LIPPERT
COMPONENTS®

Product Change Notice - In-Wall Slide-outs changing from standard to inverted gear racks

Fig.1

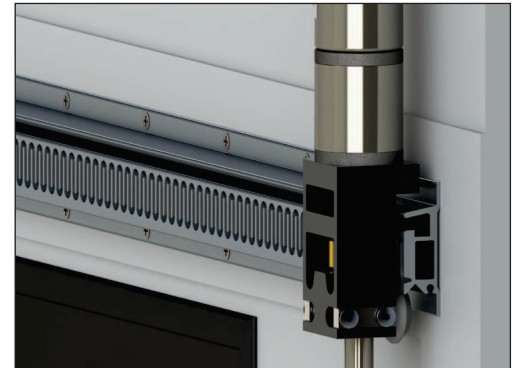
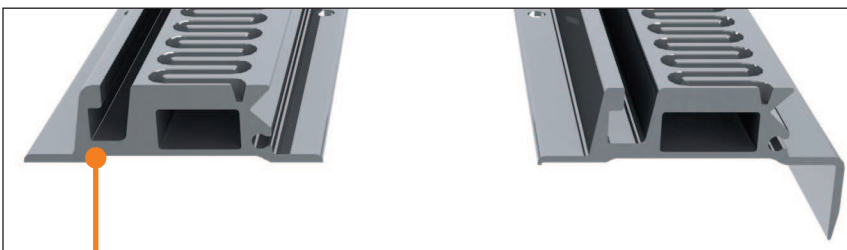
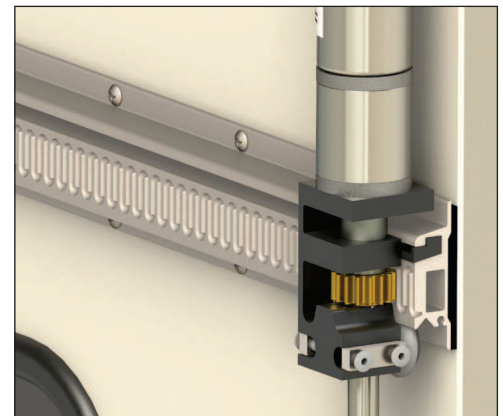
Please be advised Lippert Components is changing the gear racks on all of its In-Wall slide-out systems from standard (Fig. 1) to inverted (Fig. 2).

The inverted style is an upgraded system that allows for more efficient water deflection. The inverted racks do not allow water to pool and funnel back through the channel.

Inverted design allows for
better water deflection

Inverted Gear Rack: upper, left, lower, right.
